Project Name: Replat of D & W Subdivision

Subdivision Replat D & W Sub.
 Date 6/19/77 Item # 45-77
 Petitioner CBW Builders

Re: D & W Subdivision Construction Plans

REPLAT OF D AND W SUBDIVISION

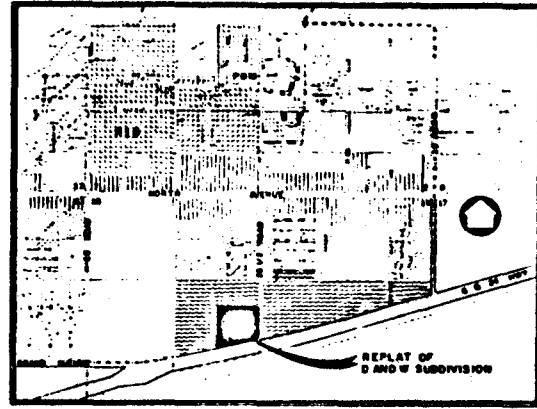
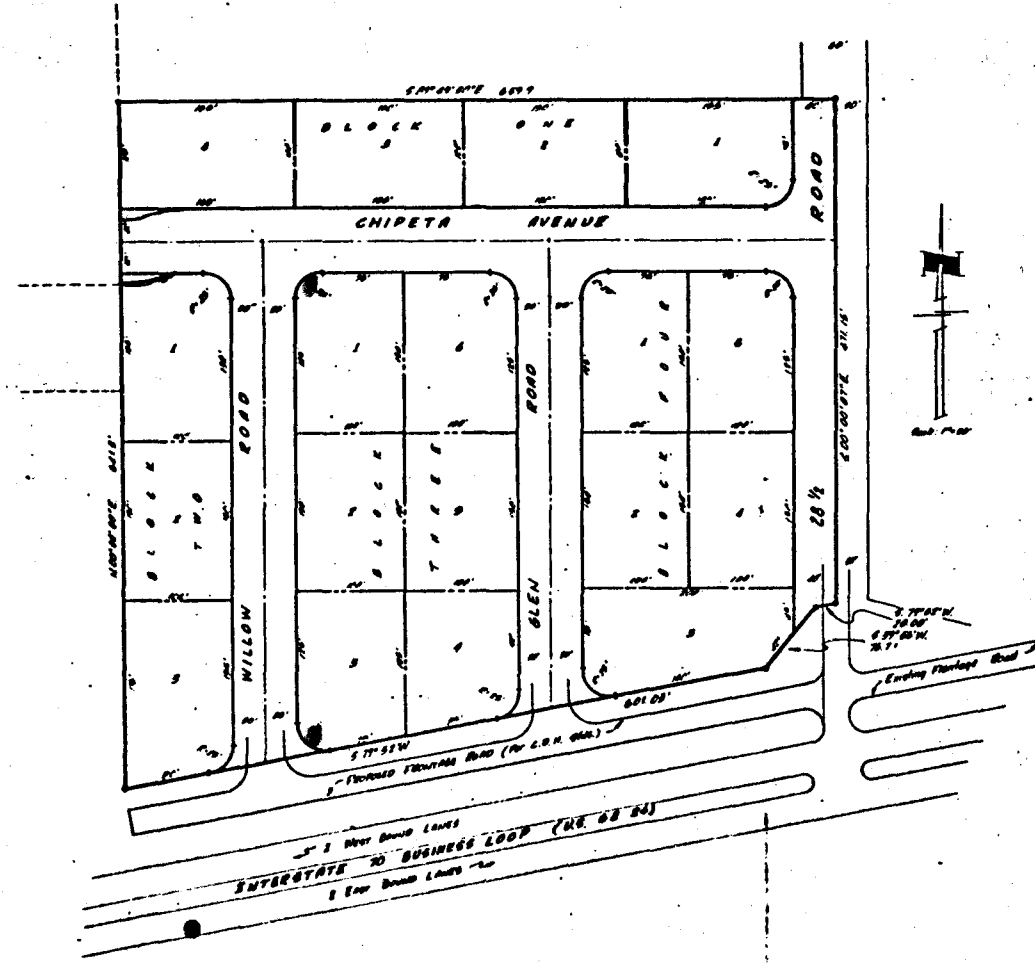
Fire Dept. - ~~1" mat 6" line~~
 w. 2 hydrants (S.W. L3B3 &
 N.W. L1B3)
 MTA Bell & P.S. - easmts
 req'd - will come in final stage
 UTIL. comp.
 Eng. - O.K. permit from (HD)
 req'd to construct frontage
 rd.

① City Eng. - ~~Roadway Sections~~
~~unacceptable~~ - should be ~~at~~
~~mat w. curb/gutter~~ both
~~sides~~. Power of alley for
 full cost imp. on 1/2
 section 28 rd. Show street
 lighting on util. comp.
 ② MTA Bell - requires
 easements
 ③ P.S. - requires easements.
 ④ Fire Dept. - 2 hydrants

Subject to review comments
& approved street improvements
(24' mat 5'-U-Pan, no parking,
pare from gutter to R.O.W. line
